Front seat belt rolls up too quickly

Topic number	LI91.40-P-060559
Version	1
Design group	91.40 Seat belts, emergency tensioning retractors
Date	01-12-2015
Validity	Model series 166 front seat belt rolls up too quickly
Reason for change	
Reason for block

Bild 1.jpg:

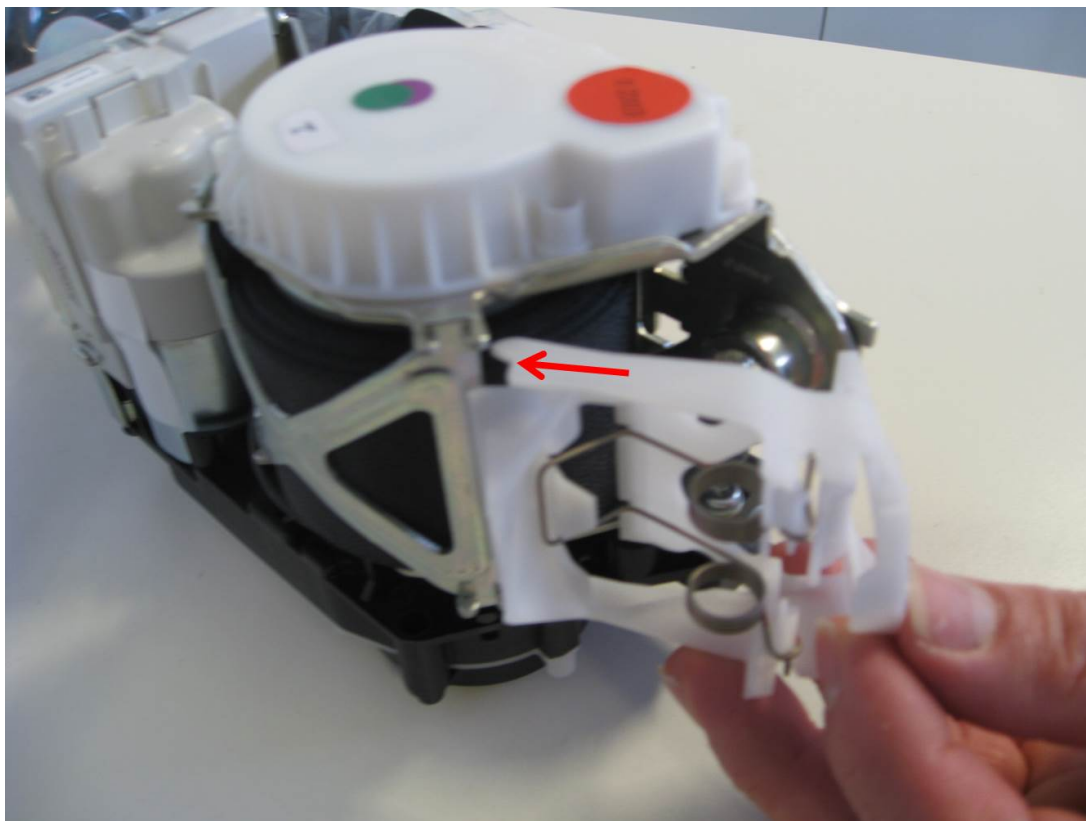
Due to differences in the forces of the retraction springs on the front seat belts, the belt strap could roll up too quickly.

1. Remove/install seat belts (front seat) AR91.40-P-1010GQ
2. Install belt tension brake on seat belts.
 - 2.1. Insert catch tab of belt tension brake in retaining plate. (Figure 1)
 - 2.2. Clip belt tension brake into bolt anchoring of seat belts. (Figure 2)
 - 2.3. Check belt tension brake for correct installation position (Figure 3)
